BEACON PLANNING BOARD
Via Video-Conference
BEACON, NEW YORK 12508
Phone (845) 838-5002 Fax (845) 838-5026

Beacon Views - Conklin Street

Continue public hearing for SEQRA environmental review on applications for Subdivision and Site Plan Approval, "Beacon Views Townhouses" 40 units, Conklin Street, submitted by Beacon Views, LLC

RE: Beacon Views Site Plan and Conservation Subdivision
Conklin Street
Beacon, New York
Tax Parcel ID: 6055-03-331123

OFF-SITE IMPROVEMENTS PLAN

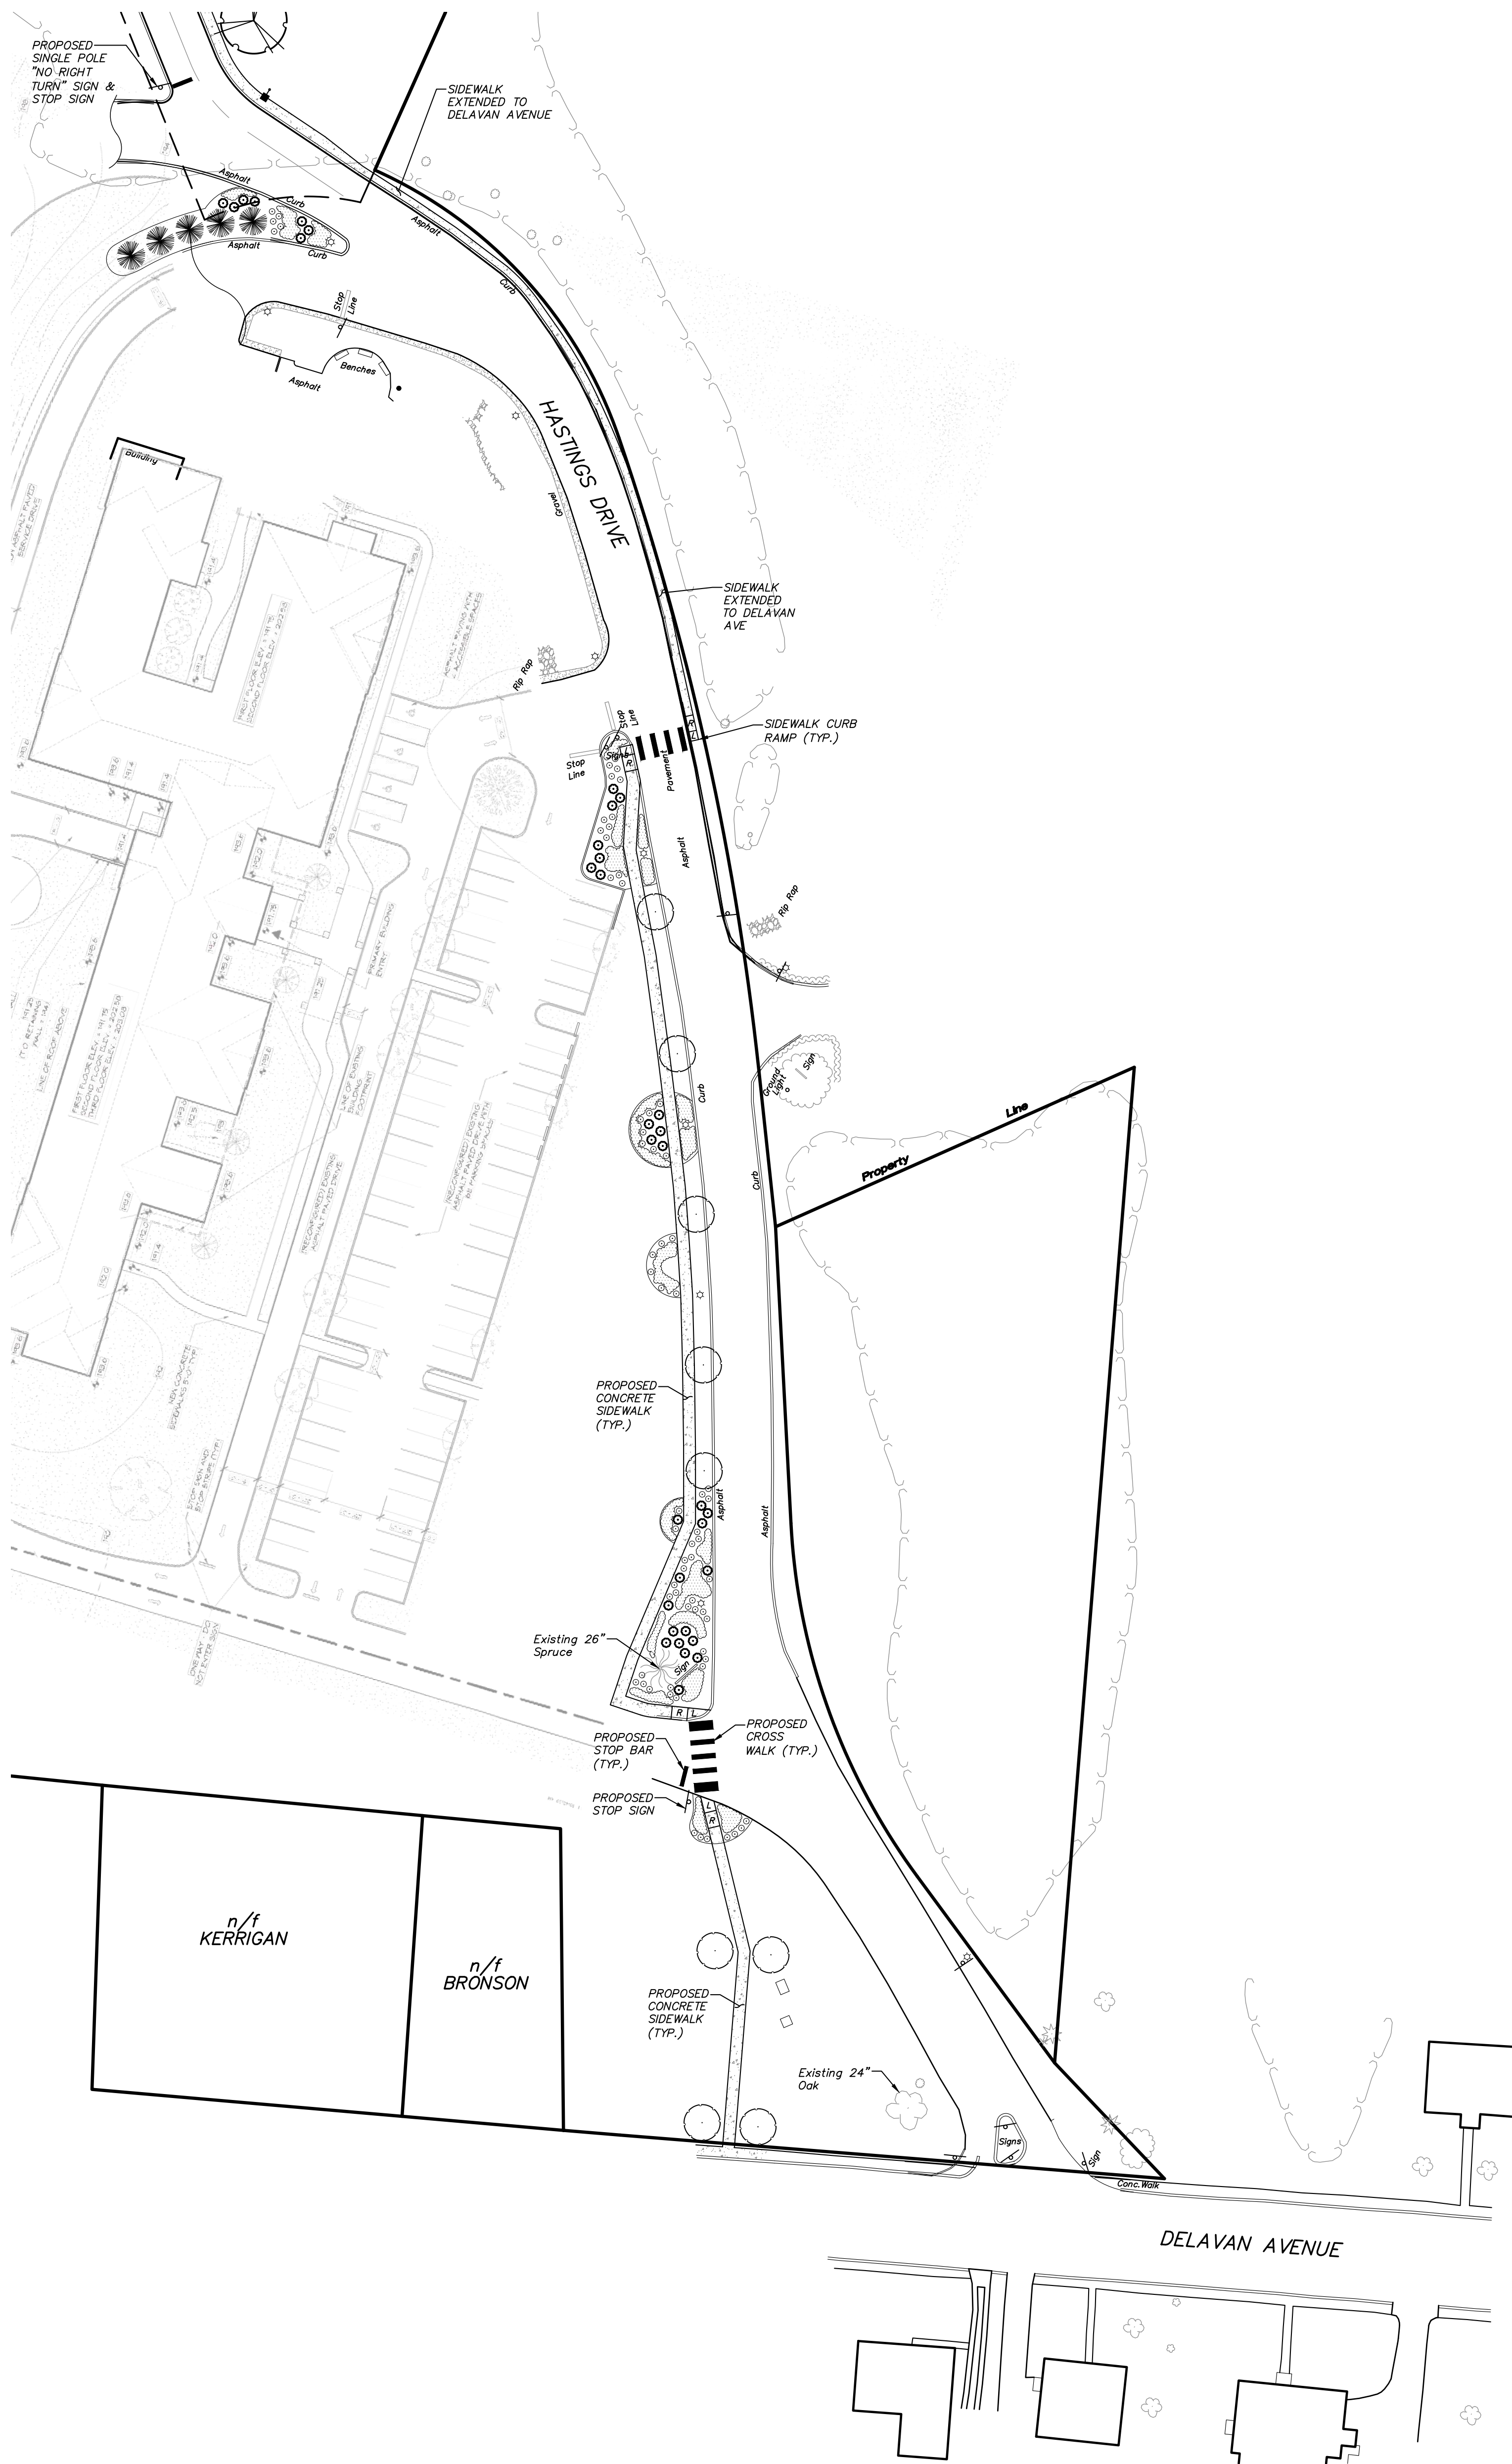
2. An Off-Site Improvements Plan has been added on Drawing SP-5.
3. The wetland mitigation area is shown both on the subject property and the neighboring parcel within the easement area. The project attorney is discussing the applicant's rights within the easement with the City attorney.

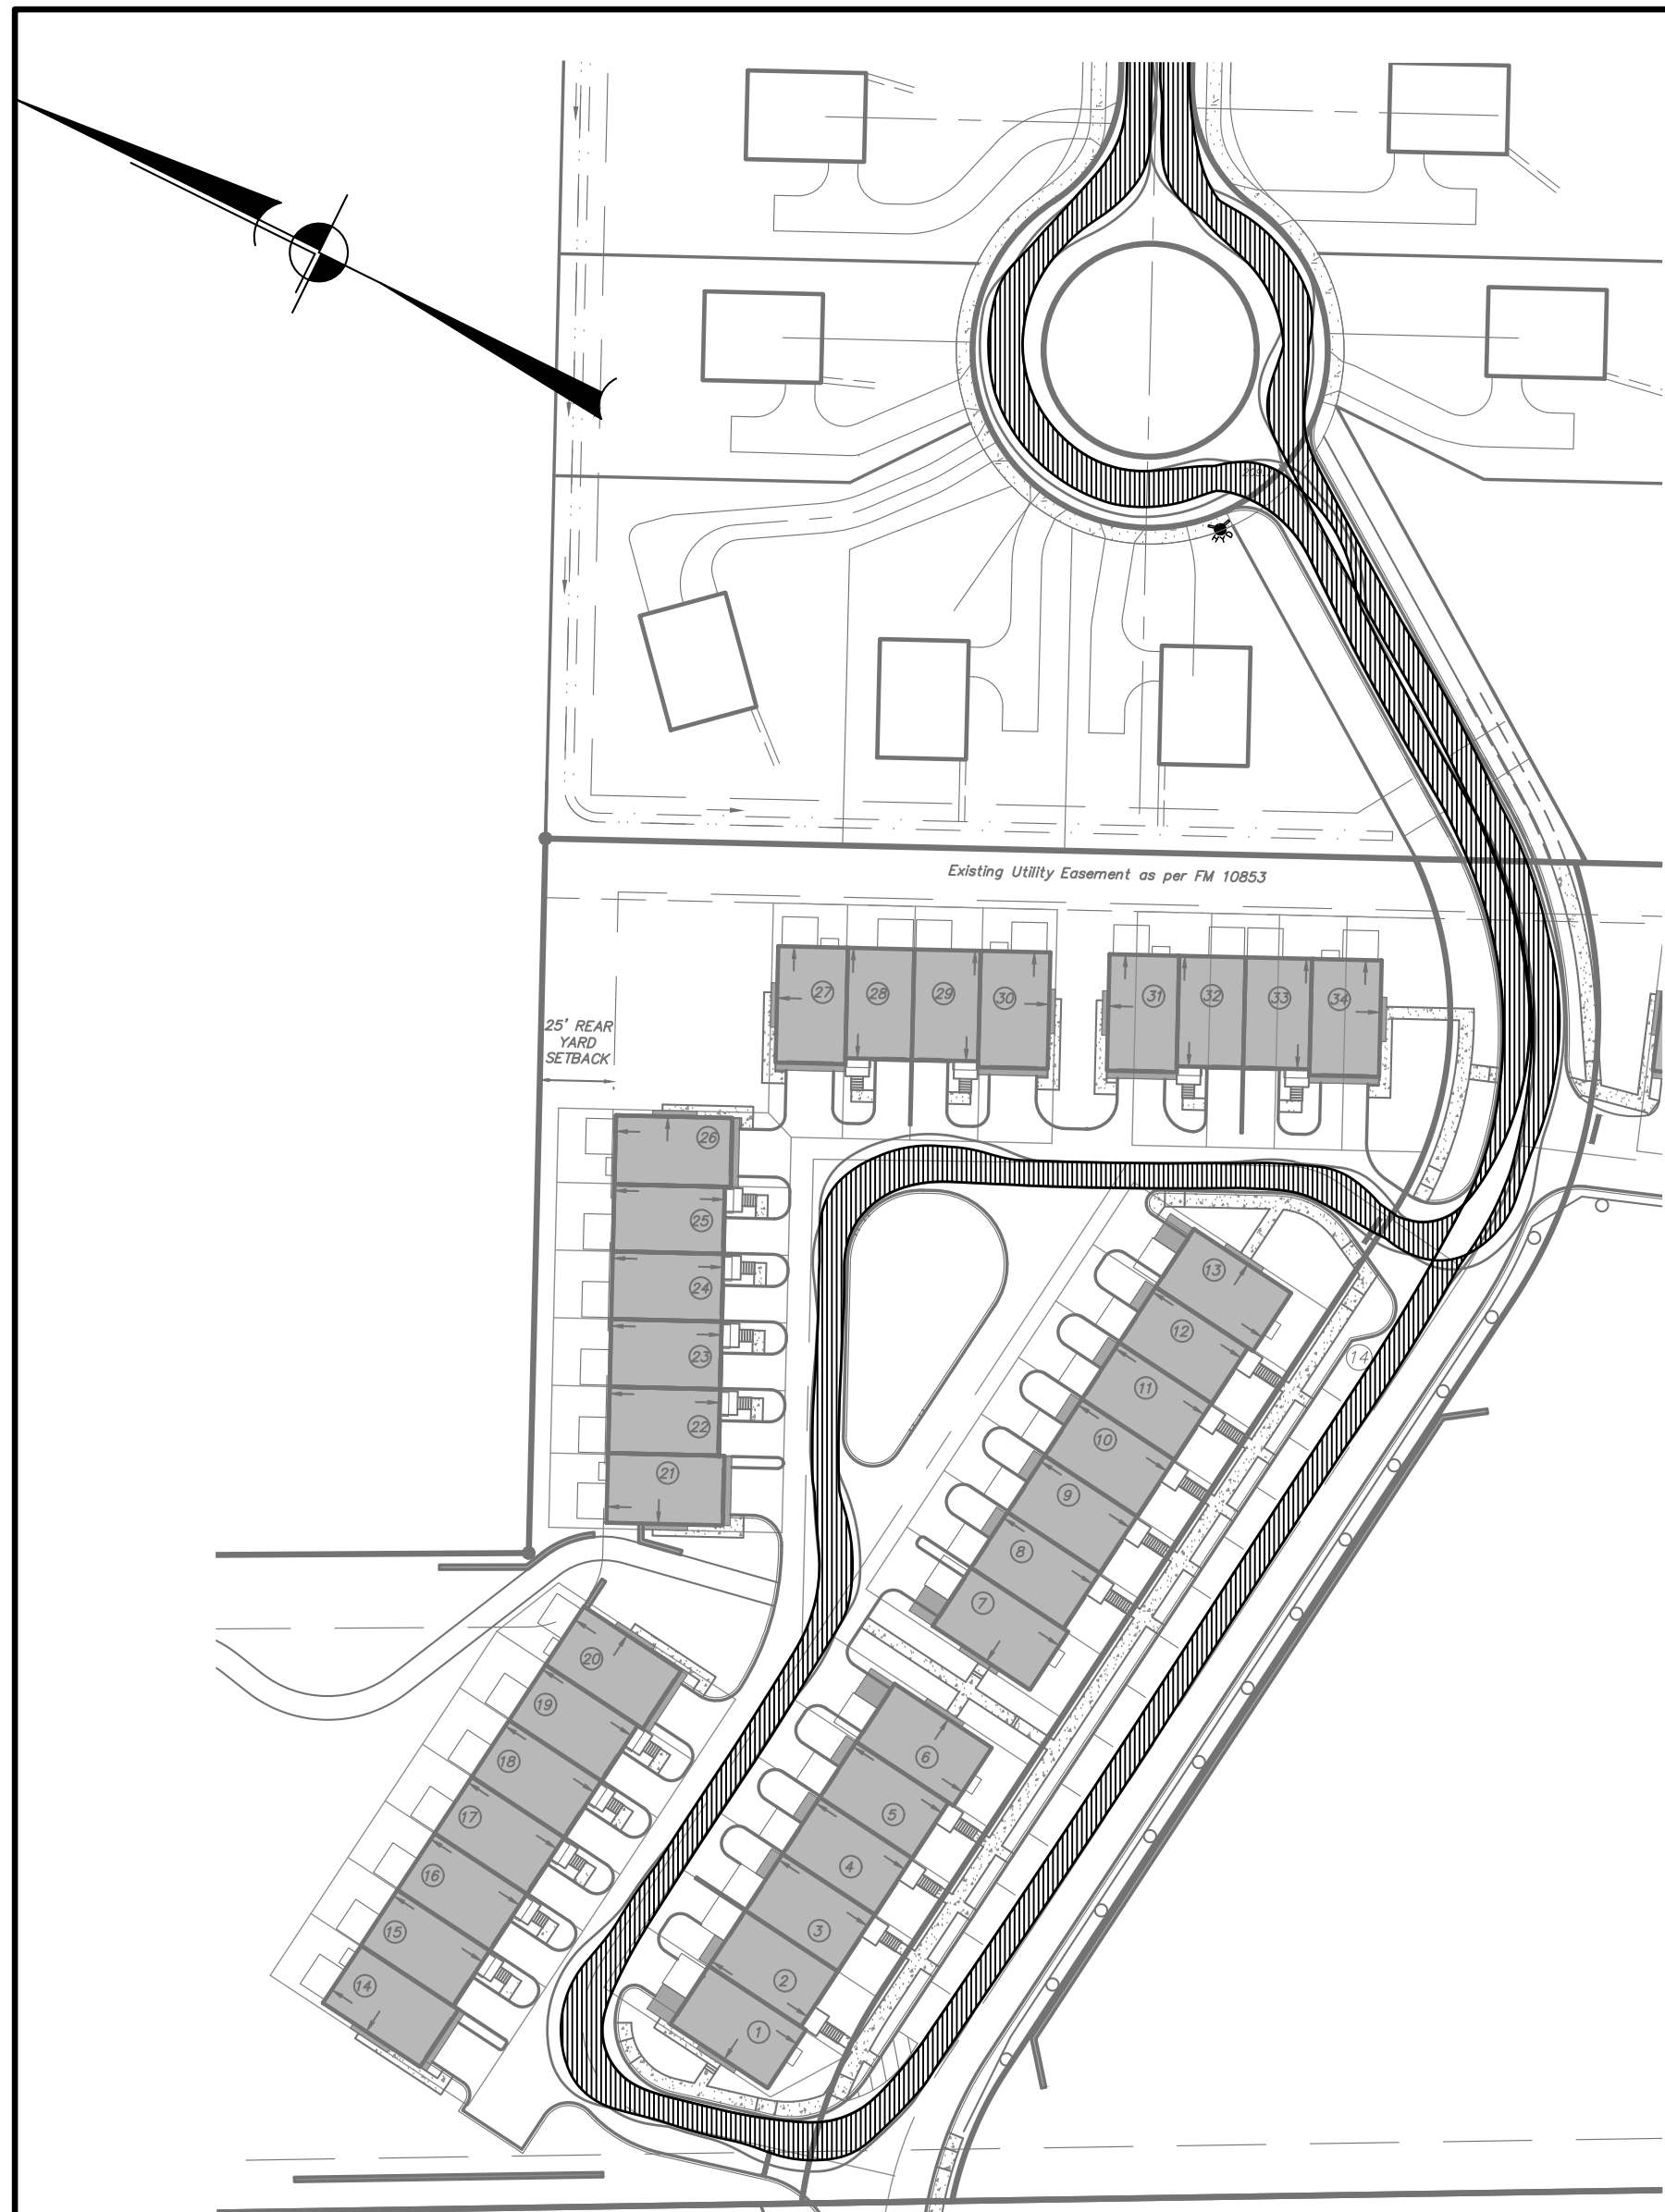
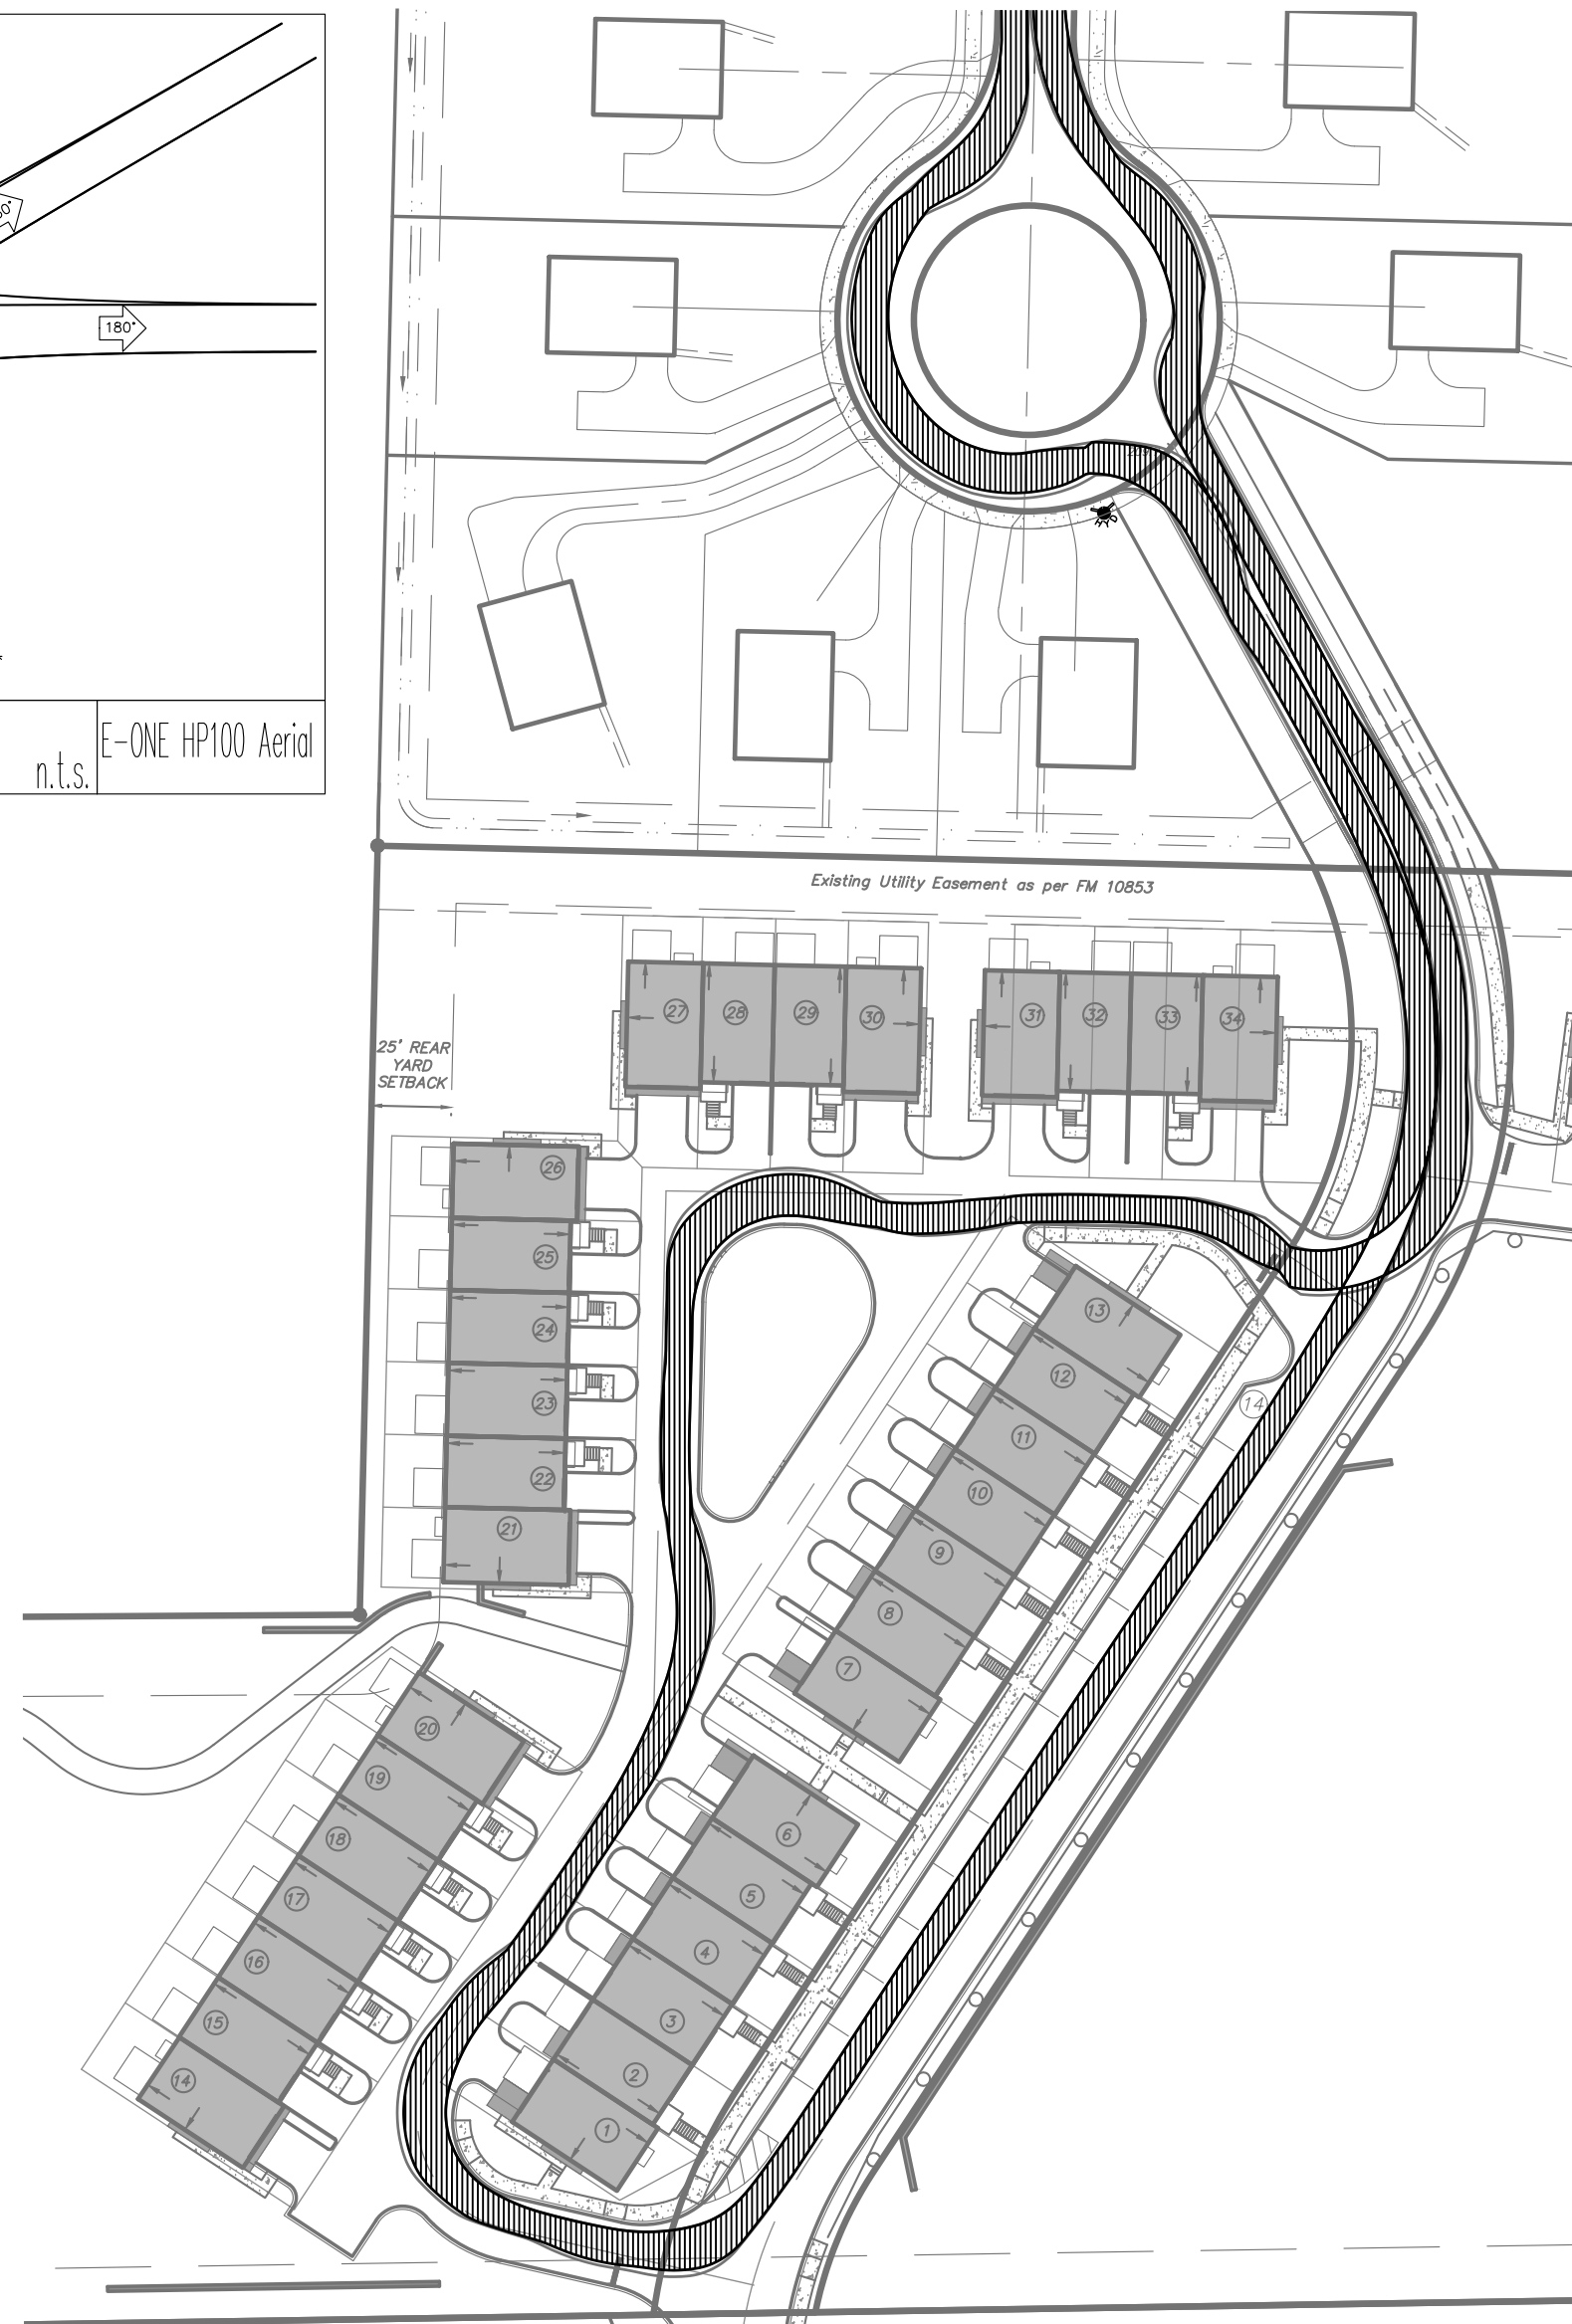
1. The details for the vehicles have been enlarged for legibility.
2. The road alignment, sidewalk layout, proposed grades, utilities, and proposed drainage modifications have been shown entering and running the extent of the pending City right of way on the 25 Townsend Street property. It is the applicant's understanding that the realignment of the 25 Townsend Street road, and how that road would connect to the right of way, including the potential elimination of the cul-de-sac, is the obligation of the owners of 25 Townsend Street.
